UNITED STATES PATENT AND TRADEMARK OFFICE

APPLICATION NO.	FILING DATE	FIRST NAMED INVENTOR	ATTORNEY DOCKET NO.	CONFIRMATION NO.
10/849,378	05/20/2004	Koichi Miyachi	1035-510	6503
23117	7590	04/05/2006	EXAMINER	
NIXON & VANDERHYE, PC 901 NORTH GLEBE ROAD, 11TH FLOOR ARLINGTON, VA 22203			CHIEN, LUCY P	
			ART UNIT	PAPER NUMBER
			2871

Office Action Summary

DETAILED ACTION

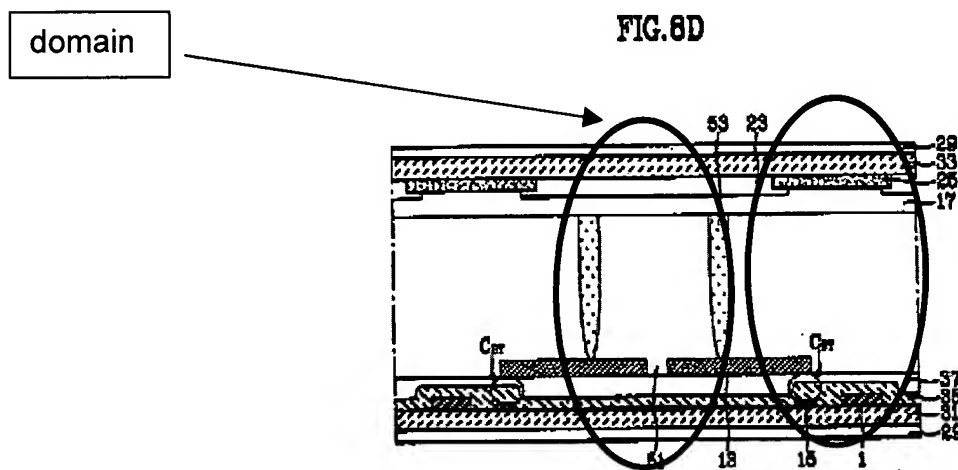
Regarding Claim 1,24,20

Kim et al discloses (Figure 8D) a pair of substrate (31,33) respectively having electrodes (17,13) on opposing surfaces, the pair of substrates sandwiching a liquid crystal layer (the space between 17 and 13).

A plurality of domains (shown below) formed within a display region when a voltage is applied to the electrodes, the plurality of domains being such that liquid crystal molecules are aligned in different directions from domain to domain, at least one of the electrodes on the pair of substrates having an aperture section (shown below). The liquid crystal layer having a plurality protrusion section (53) which connects the electrodes (17,13)

Kim et al further discloses (Figure 8D) at least one of the electrodes (13) has a protrusion (53) as the protrusion section within the display region; and a height of the protrusion is identical to a thickness of the liquid crystal layer (shown above).
